Entergy Nuclear Operations, Inc.  
Palisades Nuclear Plant  
27780 Blue Star Memorial Highway  
Covert, MI 49043

Palisades Nuclear Plant  
Docket 50-255  
License No. DPR-20

Response to Request for Additional Information Regarding License Amendment  
Request for Emergency Core Cooling Systems Surveillance Requirement  
(TAC No. MD5259)

**ENCLOSURE 1**  
**RAI RESPONSE ON ECCS SURVEILLANCE REQUIREMENT LAR**  
**PALISADES NUCLEAR PLANT**

**ATTACHMENT 2  
DRAIN PLUG CONFIGURATION**

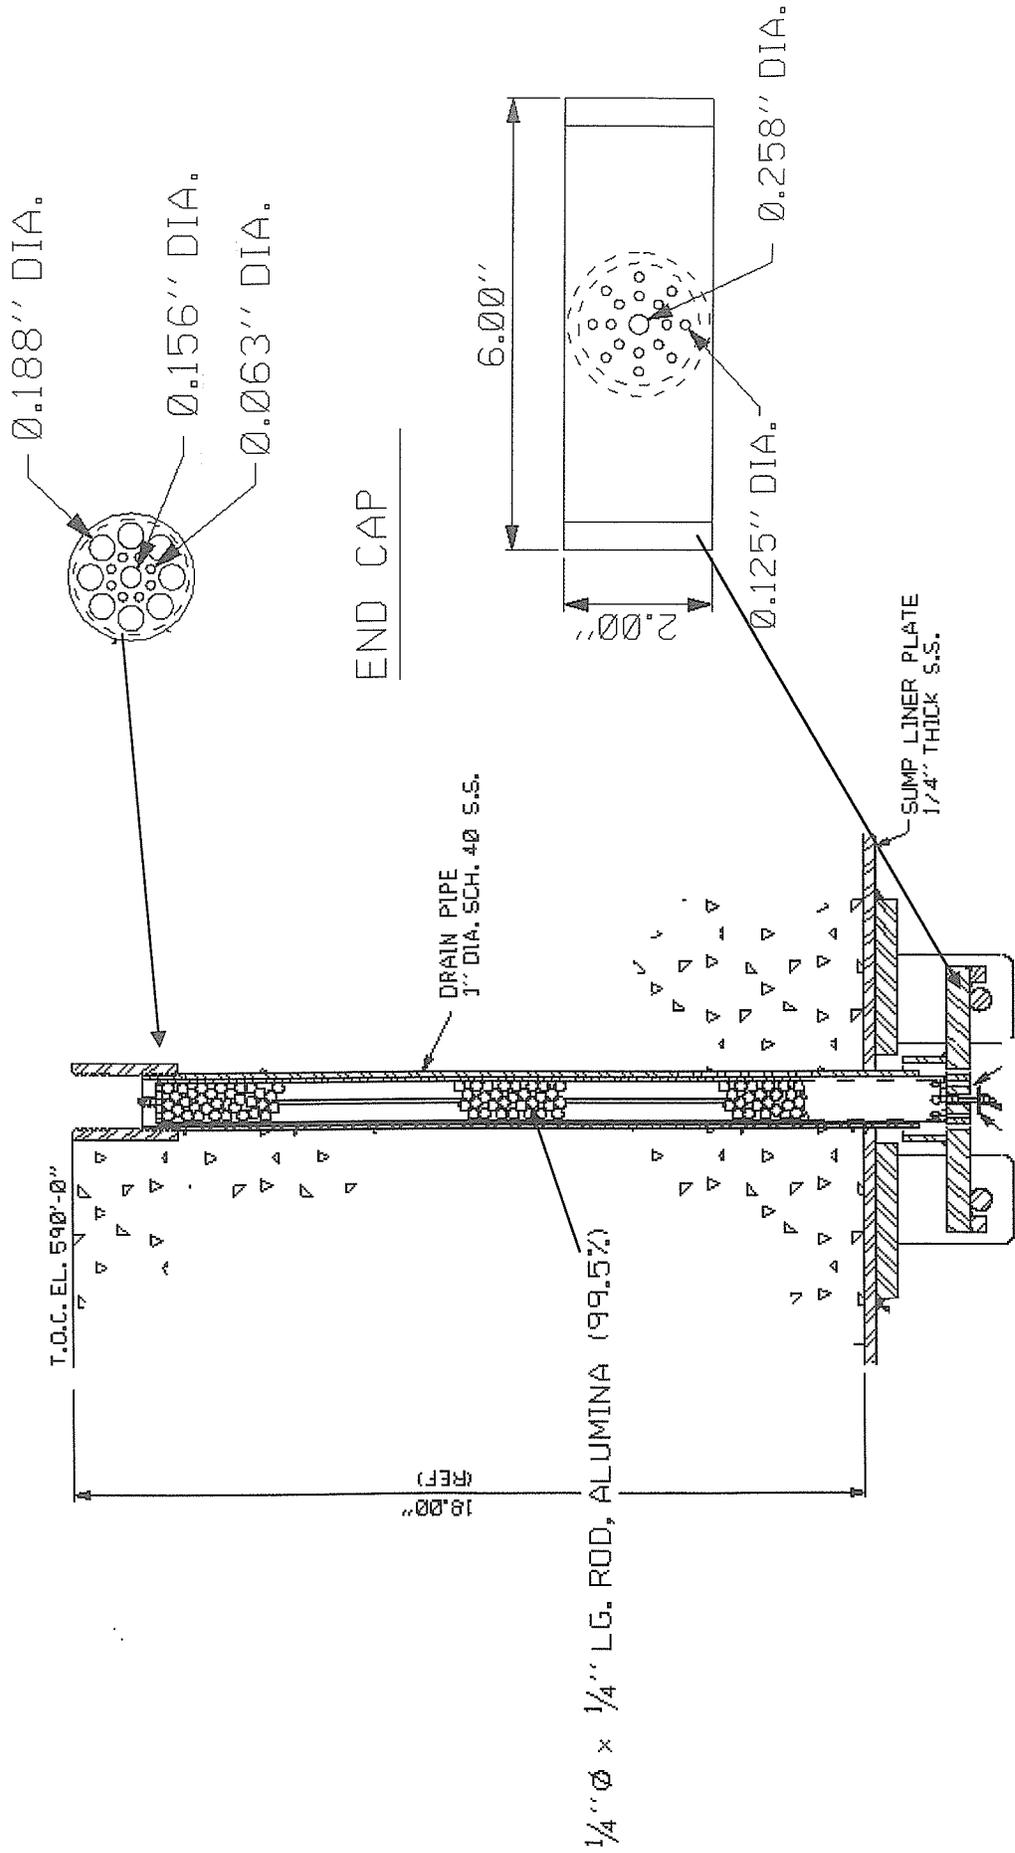
During the June 14, 2007, teleconference the NRC staff requested a more detailed description of the corium plugs and their function. This information is provided below.

The two one-inch drain lines at the bottom of the reactor cavity contain drain plugs designed to inhibit the flow of core debris (corium) into the containment sump in the event of a core meltdown and subsequent reactor vessel failure. The plugs are also designed to permit the normal flow of water through the drain lines. The corium plugs form an inherent debris screen equal to the 0.045" perforated debris screens protecting the containment sump envelope.

The details for the drain line plugs are shown on plant Drawing M74, sheet 1. A portion of this drawing showing the drain line configuration (Detail B) is provided as Attachment 1. The drain plug detail is shown on plant Drawing M74, sheet 2. A portion of this drawing showing the cavity drain plug configuration is provided as Attachment 2.

Under a design basis LOCA, the reactor cavity flooding system debris laden water collected in the floor drains above the 590' elevation transports into the reactor cavity. The post-LOCA fibrous debris transported in the reactor cavity bridges and deposits on the 0.188" and 0.063" cavity drain plug end cap openings and/or in the tortuous pathway created by the ¼" diameter, ¼" long ceramic pellets contained in the 18" long cavity drain plug, and effectively plugs and prevents debris flow through the two cavity drain lines into the containment sump.
